REGIONAL REVIEW FINDING

ARC REVIEW CODE: R1509221

Name of Proposal: Jodeco Crossings

SUBJECT: **Transportation Division Review of DRI # 2504**

Conceptual Master Plan - DRI# 2504

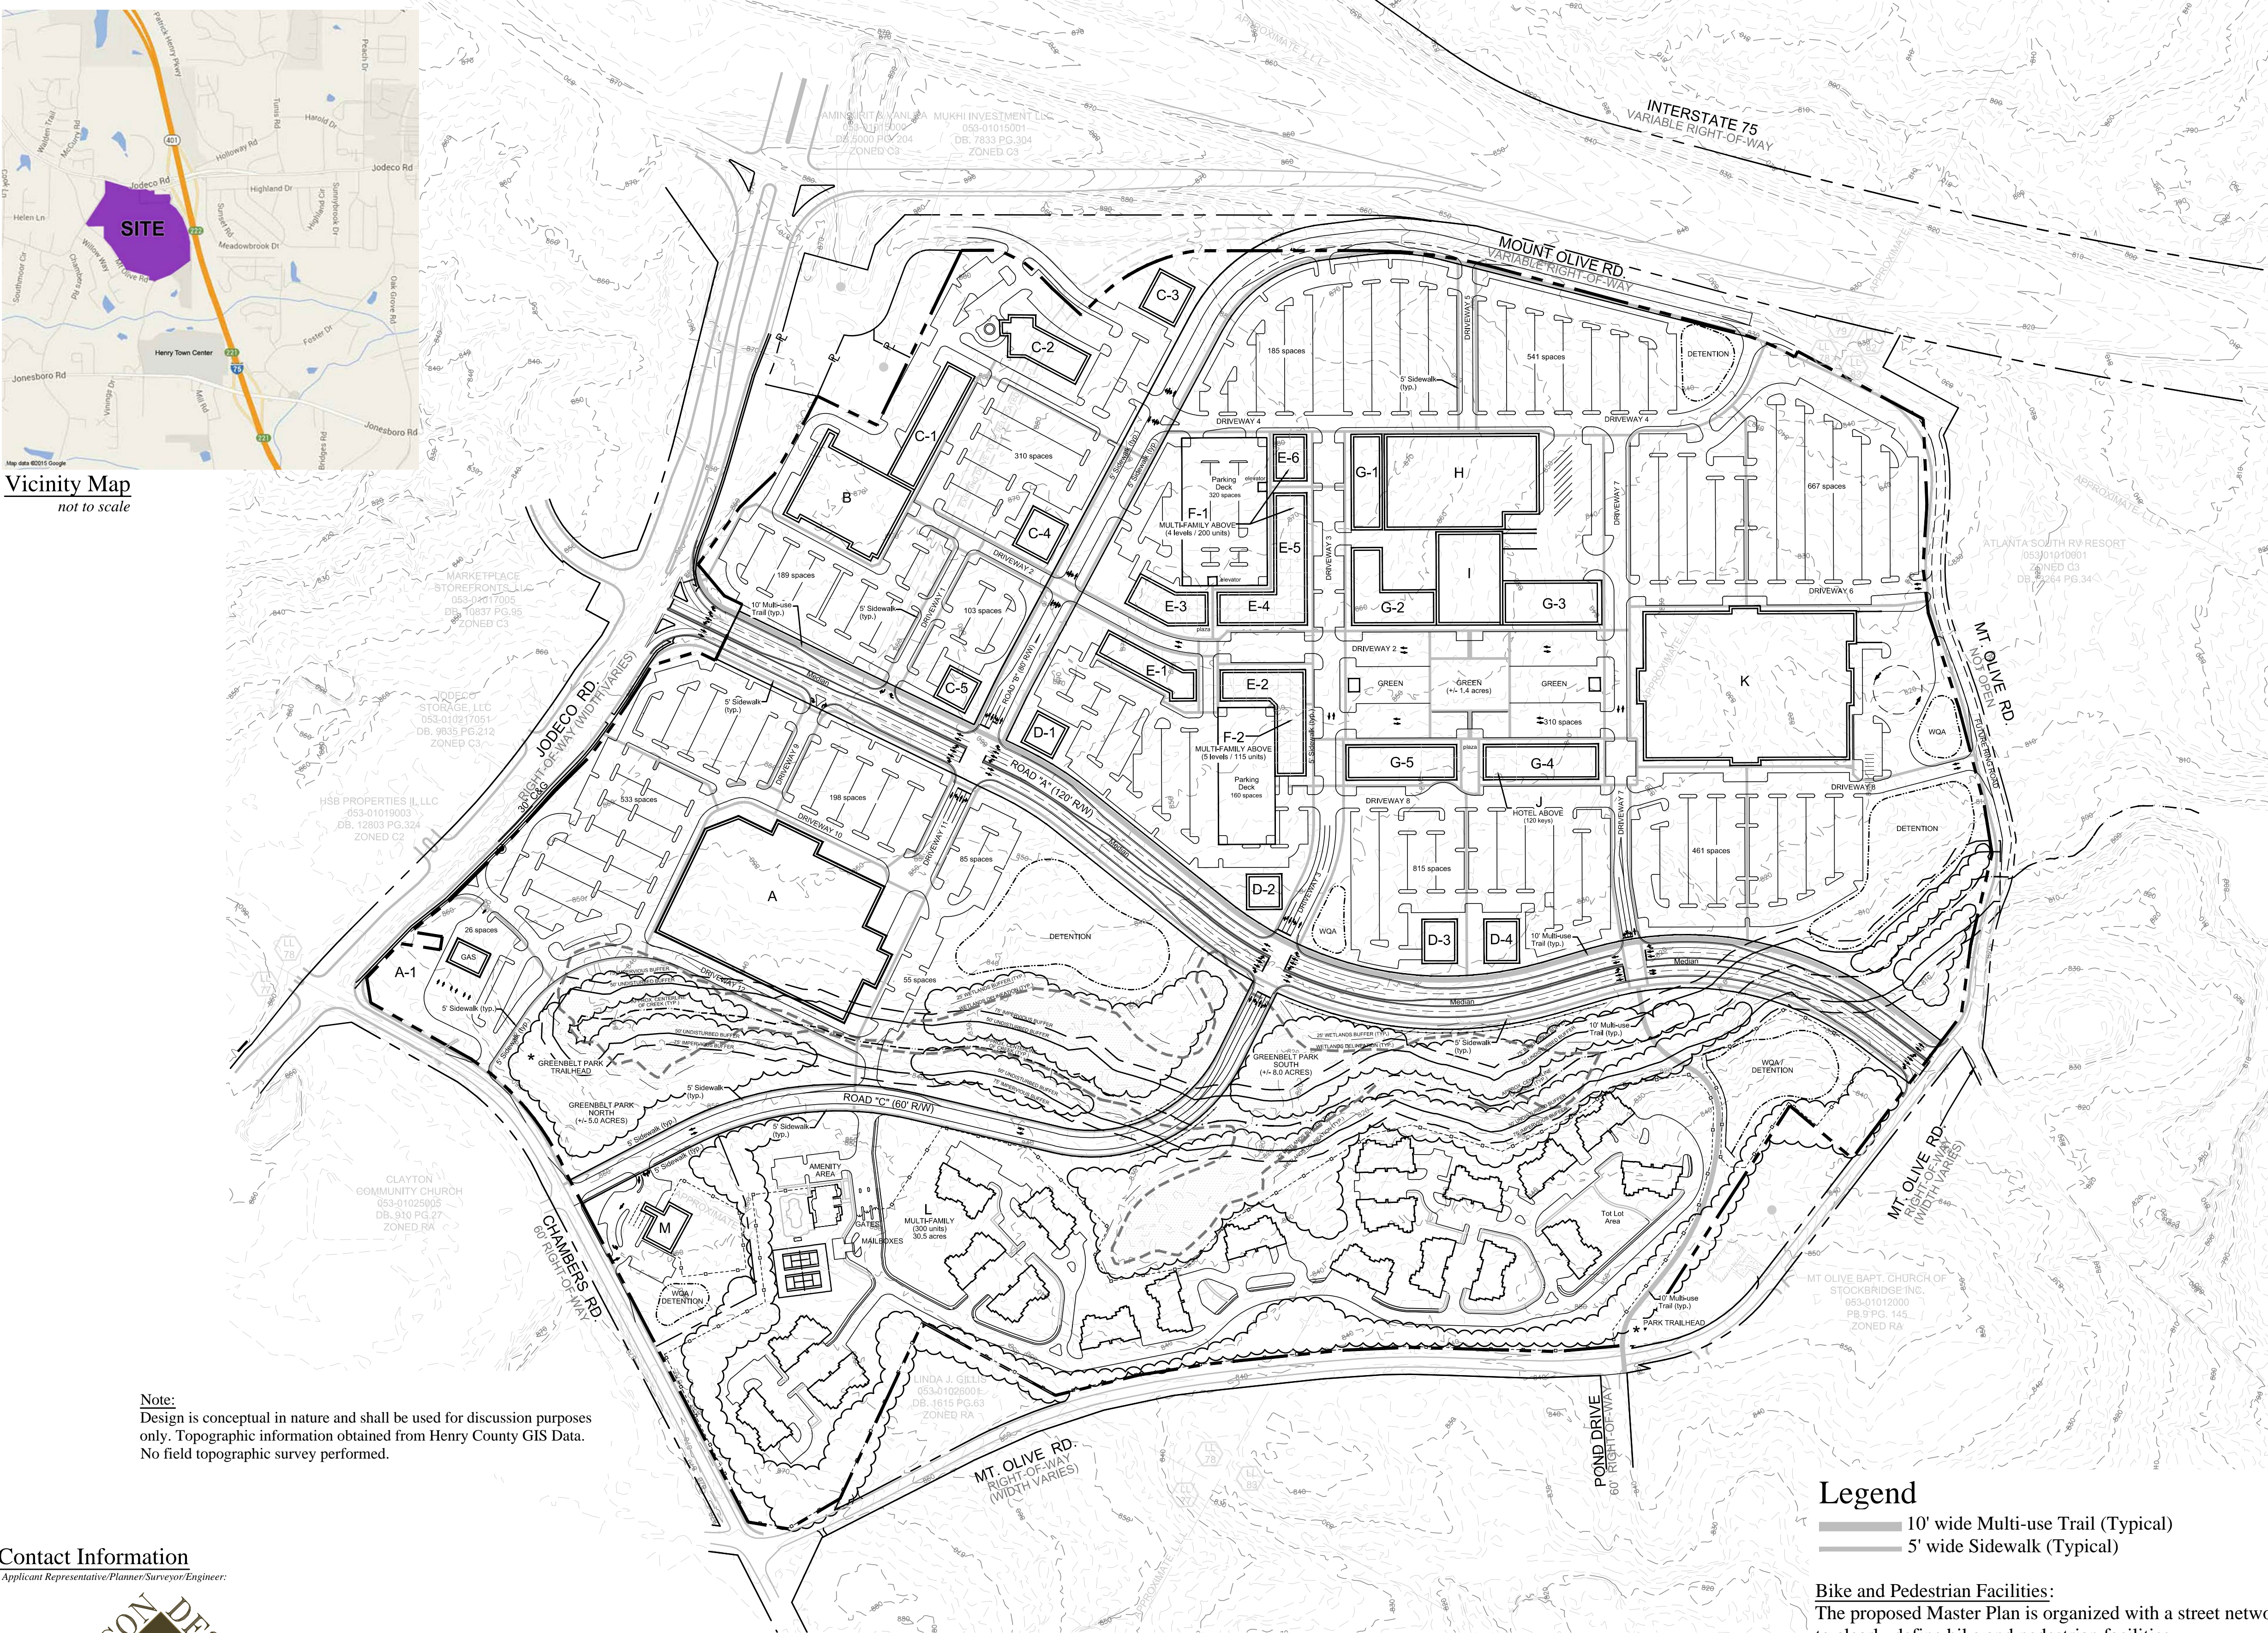
Additionally, the 300-unit multi-family complex on the west and southwest sides of the site is separated from the core of the site by a creek and wetlands, two roadways (60' and 120' rights-of-way), and several hundred feet of distance. The complex is also fenced on all sides, with one gated access point. Care should be taken to better connect this area with the rest of the site so that residents have the option to access others uses (e.g., neighborhood-serving retail, grocery, restaurants, etc.) via walking or bicycle trips.

Where parking garages are proposed, they should be screened from view to minimize visual impact, for example along the "open" frontages of the proposed garages behind Buildings E-2 and E-4, E-5 and E-6 on the site plan. The current plan proposes a large surface parking lot that fronts a large section of Jodeco Road. The developer and Henry County should explore strategies for minimizing the visual impact of this surface parking on the community.

See additional staff comments included in this report. Of note are ARC Natural Resources Division staff comments highlighting the need for the developer to ensure compliance with all applicable requirements related to water supply watersheds as well as stream and wetland buffers (with particular respect to the siting of Road A, Road C and Building A in relation to buffers).

A stream is shown on the property, running roughly north-south and dividing the multi-family section from the commercial section. A 50-foot undisturbed buffer and 75-foot impervious surface setback are shown along the stream, which conform to the requirements of Henry County's Stream Buffer Ordinance. However, the proposed specialty retail superstore site identified as Building A on submitted Plans, along with portions of Roads A and C intrude on those buffers. Any intrusion into the buffers may require a variance from Henry County.

The project plans also show several wetlands areas on the property. These areas will be subject to all applicable US Army COE requirements under Section 404 of the Clean Water Act. These wetland areas as well as all other waters of the state on the property, including the mapped stream, are also subject to the State Erosion and Sedimentation Act requirements, which include buffers.
